THANET DISTRICT COUNCIL

MANSTON AIRPORT NIGHT NOISE ASSESSMENT REVIEW

4222827/R01

November 2010

Figure 5: Night-time Noise Exposure Analysis – dwellings and population within the 54 dB L_{Aeq,8h} contour, per million passengers

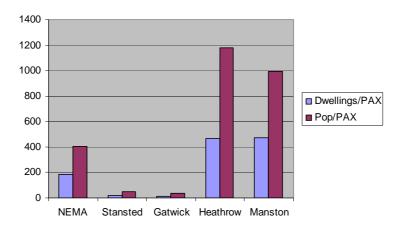
- 4.6.9 This analysis shows significant variation between airports. Heathrow clearly causes the greatest normalised disbenefit owing to the fact that it is located close to the highly populated areas of west London, despite the fact that it caters for twice the number of passengers of the next busiest airport, Gatwick, which affects comparatively few people hence the low normalised disbenefit. Stansted is a similar example to Gatwick. The normalised disbenefit for regional airports such as NEMA is somewhere in the middle as the low passenger throughput pushes up the normalised disbenefit despite the comparatively few people exposed to noise. On the basis of the forecasts, however, MSE is showing a greater normalised disbenefit to that of Heathrow in terms of dwellings exposed to 54 dB L_{Aeq,8h}. In fact, the predicted number of people exposed to this level of noise at MSE is over double the number that were exposed to noise at Stansted and at Gatwick airports which cater for 10-15 times the number of passengers.

- 4.6.10 This is a slightly unfair analysis as it is relating night noise impact against total passenger throughput. It would be helpful to have an idea of the likely night time passenger throughput (and freight movement) during the night for MSE and other airports so the relative impact of the night activity can be estimated.
